# Access Compliance Report Public Rights-of-Way (Curb Ramps)

Main Street: TAFFETA\_LN Cross Street: LODEN\_PASS Location: N

ADA ID: RPRK211104130809 Ramp Type: Type 4 - Parallel Initial Pass/Fail: Fail Overall Compliance: No Severity Score: 15

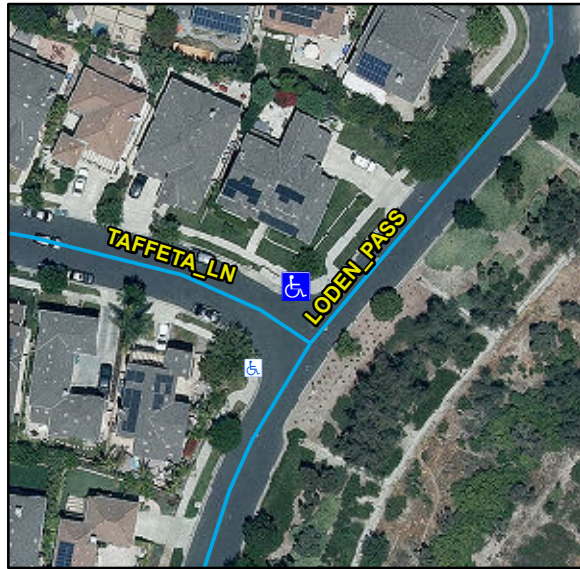
| Compliance | Description                   | Data       | Compliance | Description                   | Data |
|------------|-------------------------------|------------|------------|-------------------------------|------|
| Yes        | Ramp Run Slope LT (%)         | 0.1        | No         | Ramp Run Slope RT (%)         | 8.7  |
| N/A        | Gutter Cross Slope (%)        | N/A        | No         | Perpendicular Joint Present   | No   |

Remove & Replace Curb Ramp With Two New Directional Ramps or Equivalent.

R204.3, R304.3.2, STD 1115
